**DOCUMENT 00 90 00
ADDENDUM**

ADDENDUM NO. [1] Date: August 14, 2019

**RE: LANESBORO PUBLIC SCHOOLS
 ADDITION AND REMODEL
 100 KIRKWOOD ST EAST
 LANESBORO, MN 55949
 HSR 18063**

**FROM: HSR Associates, Inc
 100 Milwaukee Street
 La Crosse, WI 54603
 (608) 784-1830**

P107

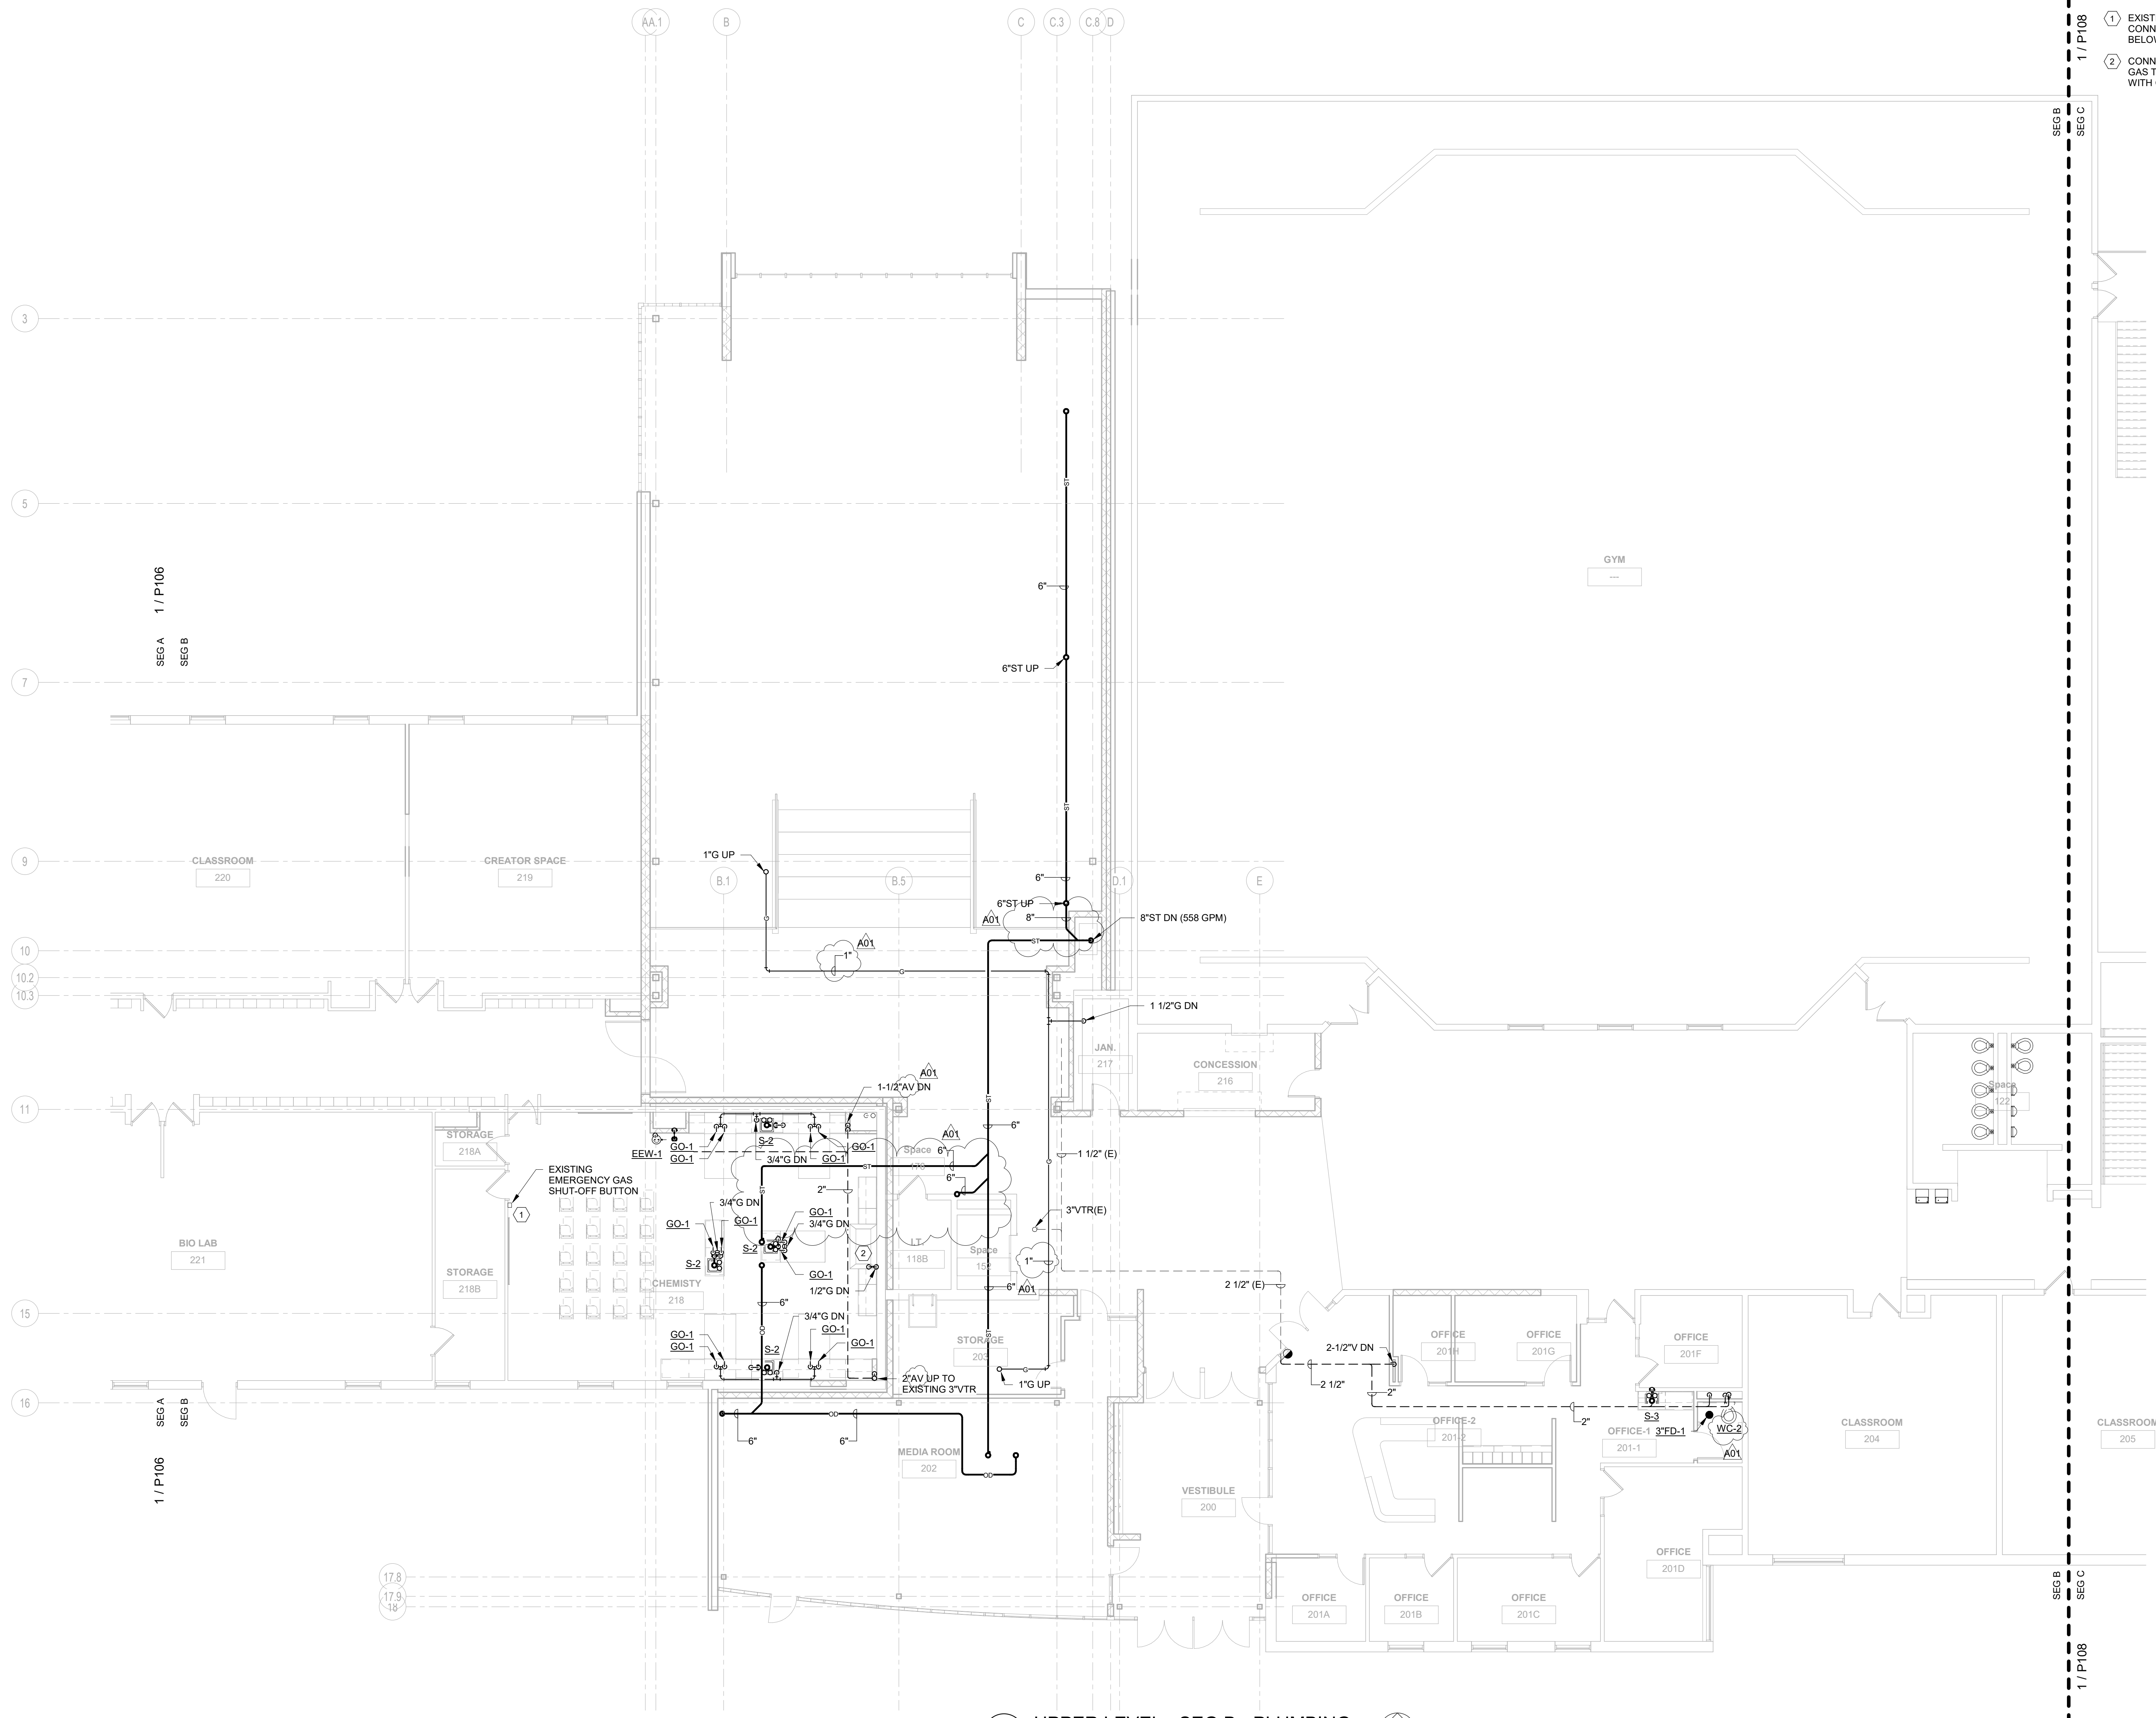
- f. Add sanitary piping for added hub drain above, as shown.
35. Sheet P107 UPPER LEVEL - SEGMENT B – PLUMBING 30 x 42 attached hereto
 - a. Revisions clouded on Drawing.

- b. Add pipe sizes, as shown.
 - c. Revise ADA water closet callout to WC-2, as shown.
 - d. Revise location of storm over IT room, as shown.
36. Sheet P108 UPPER LEVEL - SEGEMENT C – PLUMBING 30 x 42 attached hereto

P108

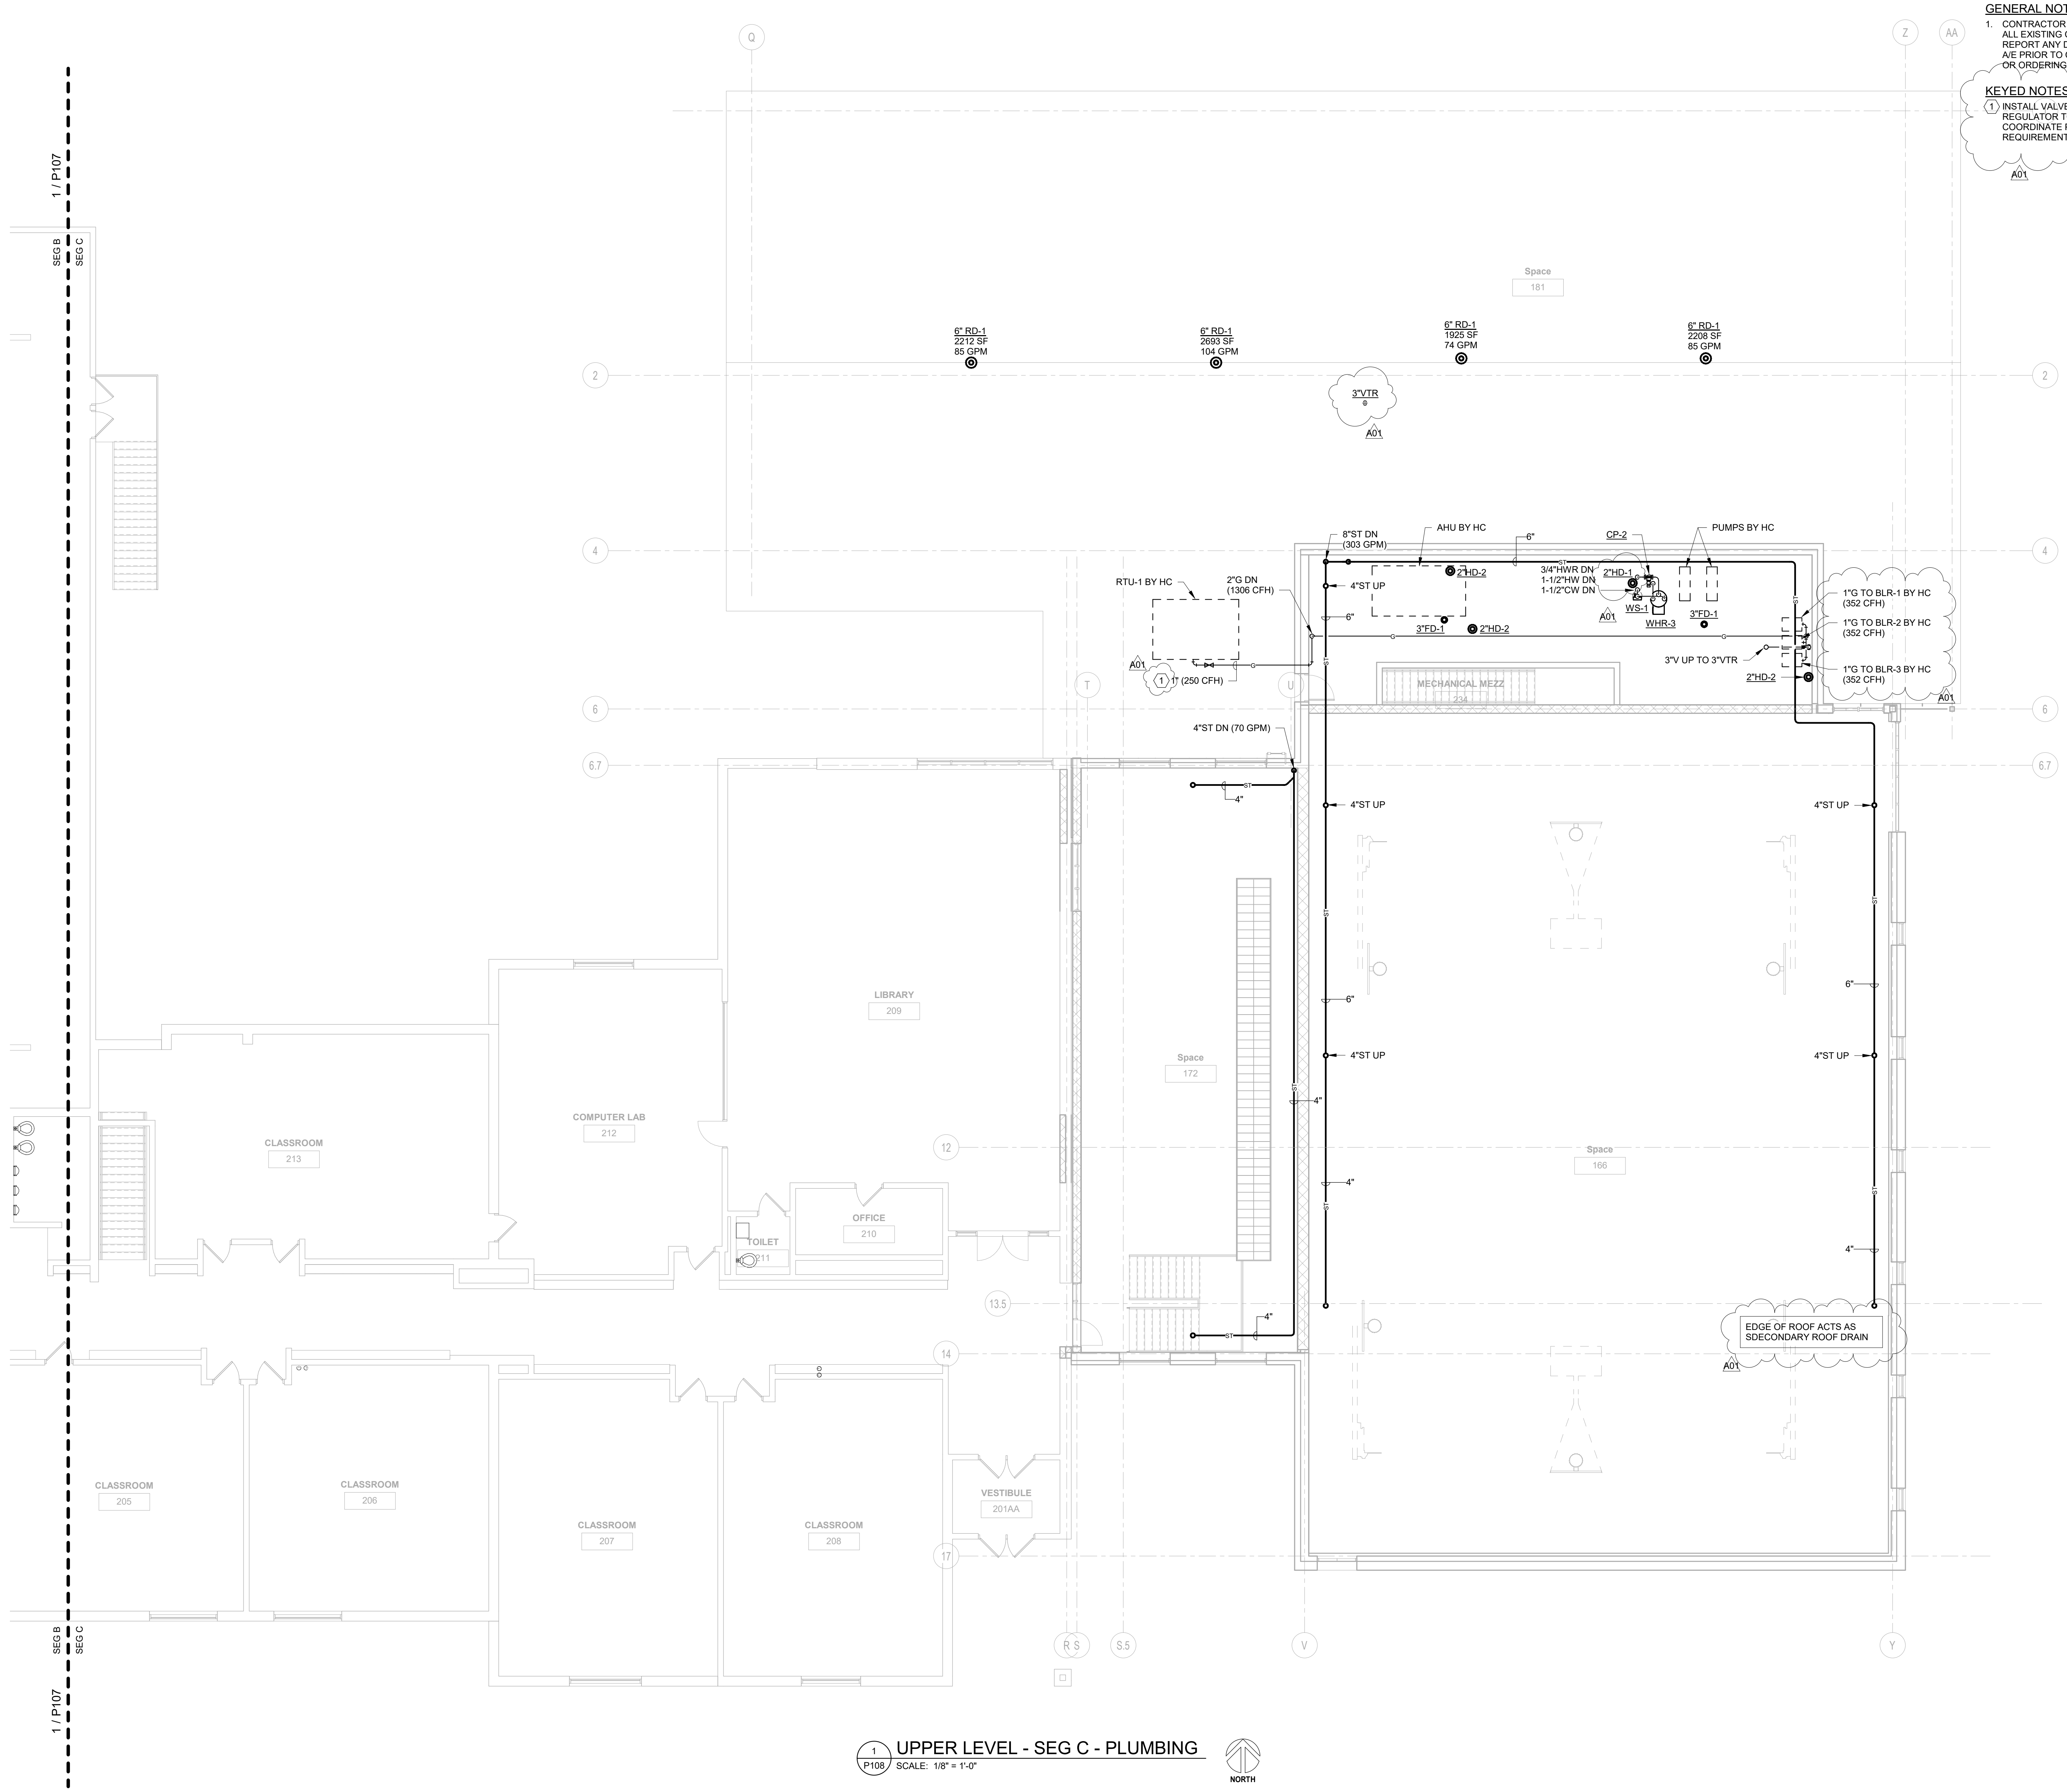
- a. Revisions clouded on Drawing.
 - b. Add pipe sizes, as shown.
 - c. Add hub drain by water softener, as shown.
 - d. Add vent thru roof, as shown.
 - e. Add notes, as shown.

P120

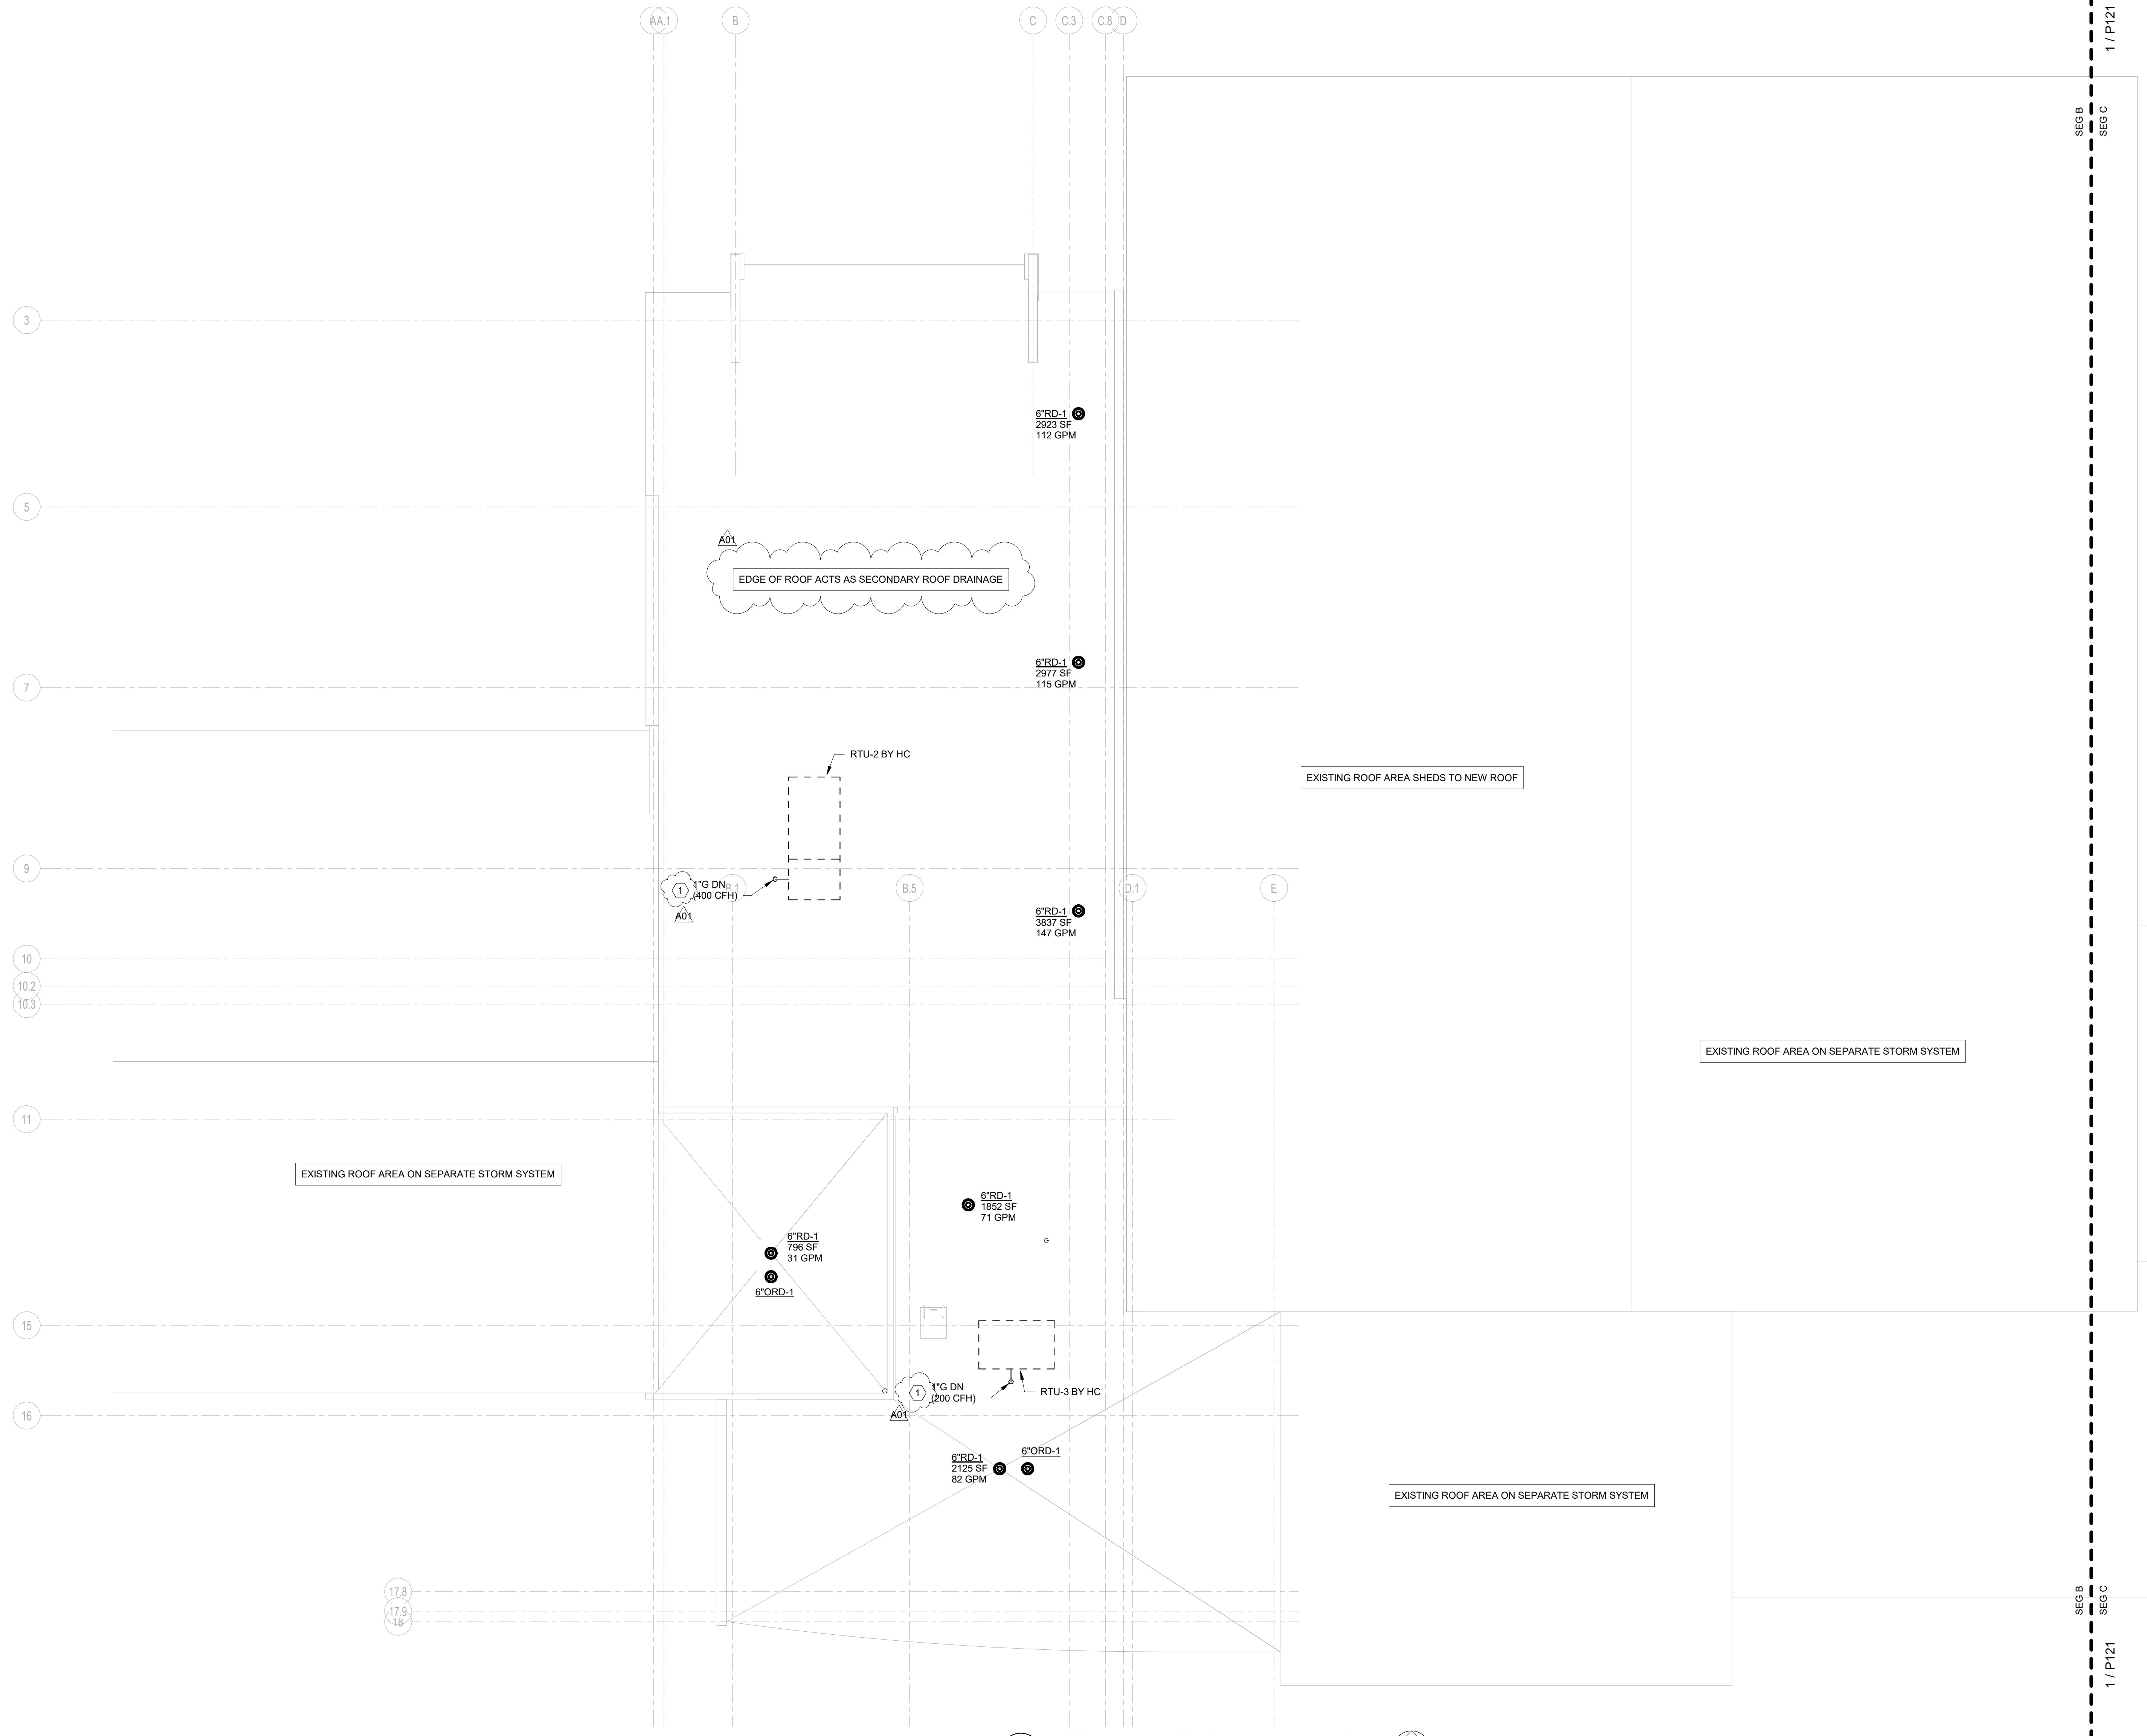
37. Sheet P120 ROOF PLAN – SEGMENT B - PLUMBING 30 x 42 attached hereto
 - a. Revisions clouded on Drawing.
 - b. Add notes, as shown.
38. Sheet P121 ROOF PLAN – SEGMENT C - PLUMBING 30 x 42 attached hereto
